Agency Comment

Jon Gorin stated in an e-mail dated July 25, 2013 that a comment was submitted by NJDEP to the National Remedy Review Board (NRRB) prior to its meeting about the LCP site on June 26, 2013, as follows:

RE: Comments on the Site Characterization Summary Report (SCSR), LCP Chemicals, Inc. Superfund Site, Linden, New Jersey, dated August 2002

Re: Comments on the Phase II Remedial Investigation Work Plan and the Historic Drainage Analysis Report for the LCP Chemicals, Inc. Superfund Site, Linden, New Jersey

FIGURE X-X
RESIDUAL ORGANIC LIQUID SATURATION
IN SUBSURFACE SOILS

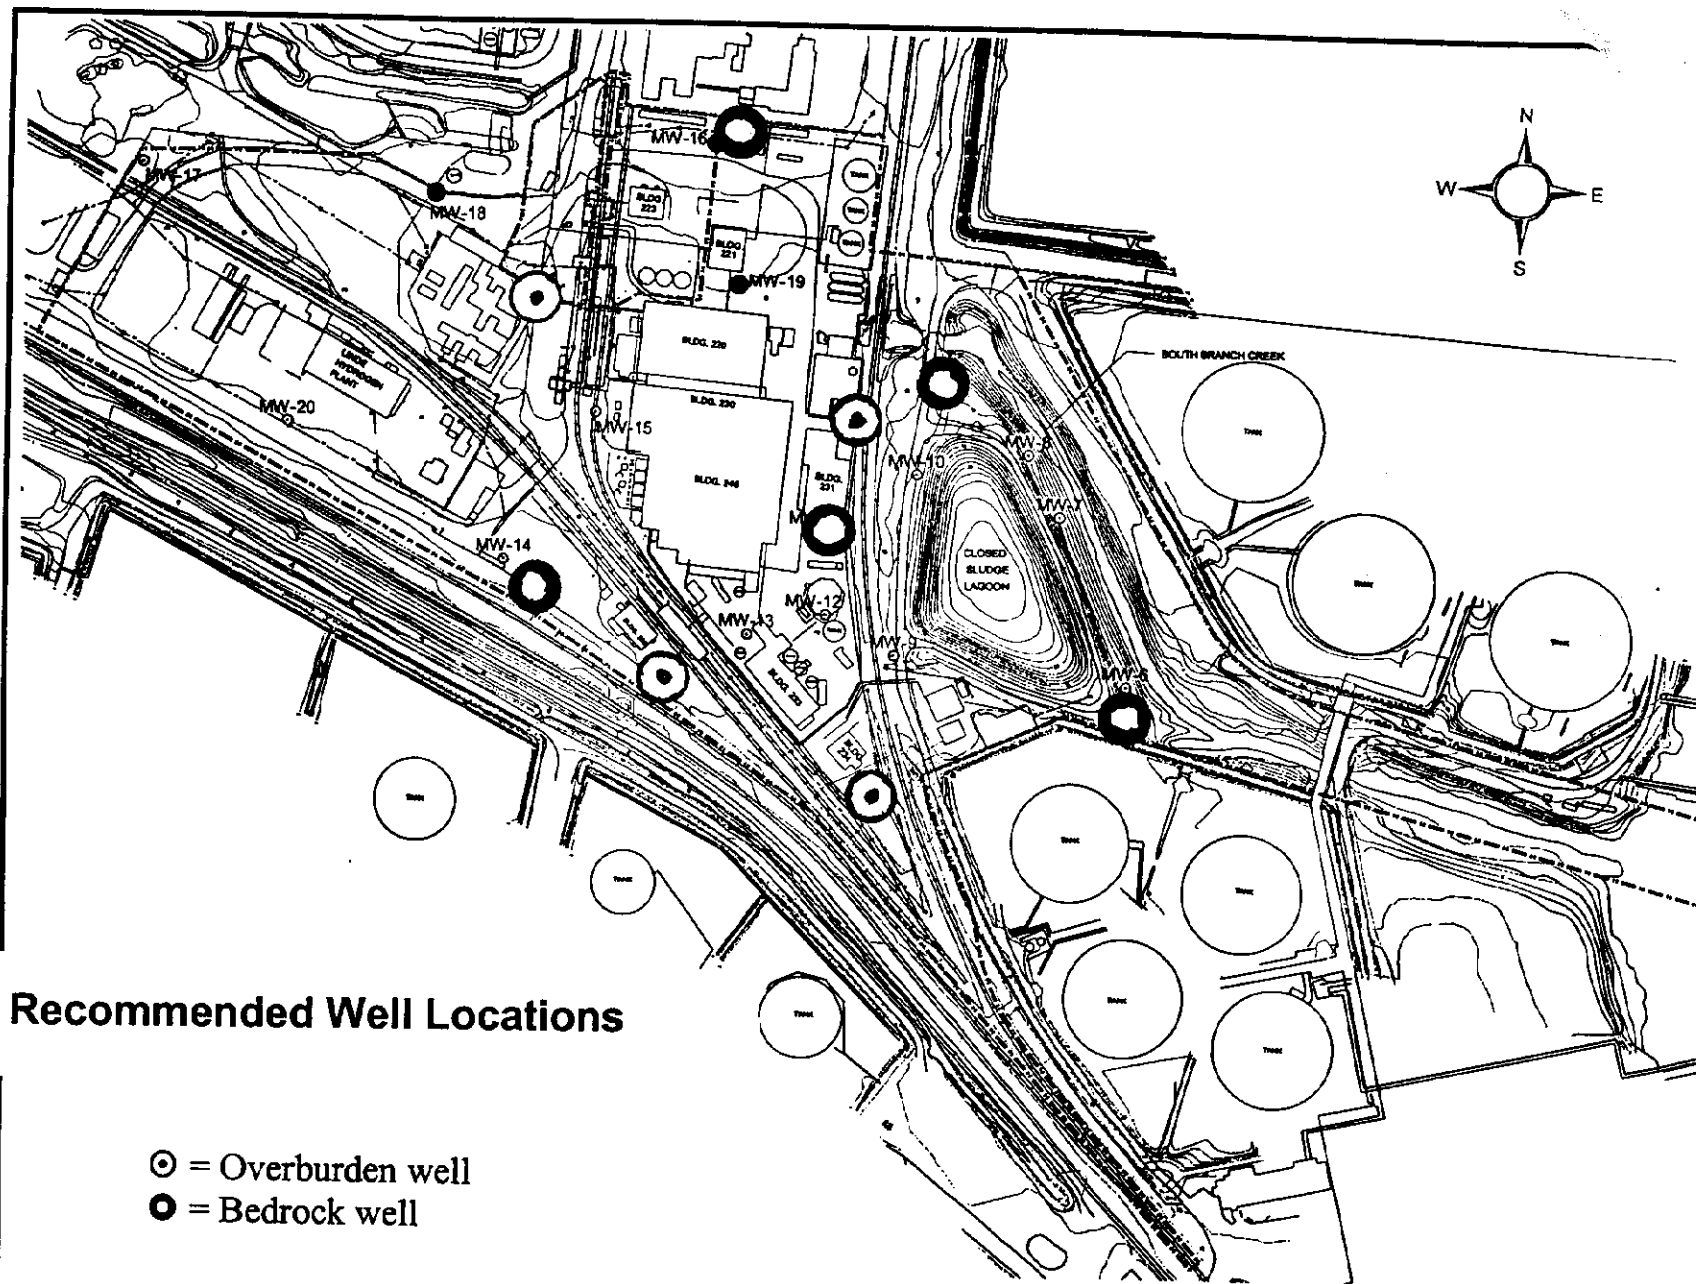
- **Available Information:** The areal distribution and depth of the samples containing observed residual saturation of organic liquids (also referenced on Table 6-15) are shown on the attached Figure.
- **Conclusions:**

- The locations of the samples containing observed residual saturation of organic liquids are grouped in several areas of the site. These areas include the so-called “Ditch Bridge” area located in the north-central portion of the site, along the east and south sides of the former production area, and in proximity to the railroad tracks within the southern point of the property. While there are these groupings, there are numerous other soil borings in the same areas in which non-aqueous phase liquids were not observed. Therefore, the relatively discontinuous areal distribution of these samples is inconsistent with a laterally continuous layer of non-aqueous phase liquids.

- The depths of the soil samples listed on Table 6-15 typically range from 4 to 11 feet below ground surface within the anthropogenic fill which in nearly all cases is below the water table. Furthermore, one referenced sample was collected at a depth of 26 to 28 feet within the glacial till. The observed depths of the samples are inconsistent with the presence of a floating layer of “free product”.
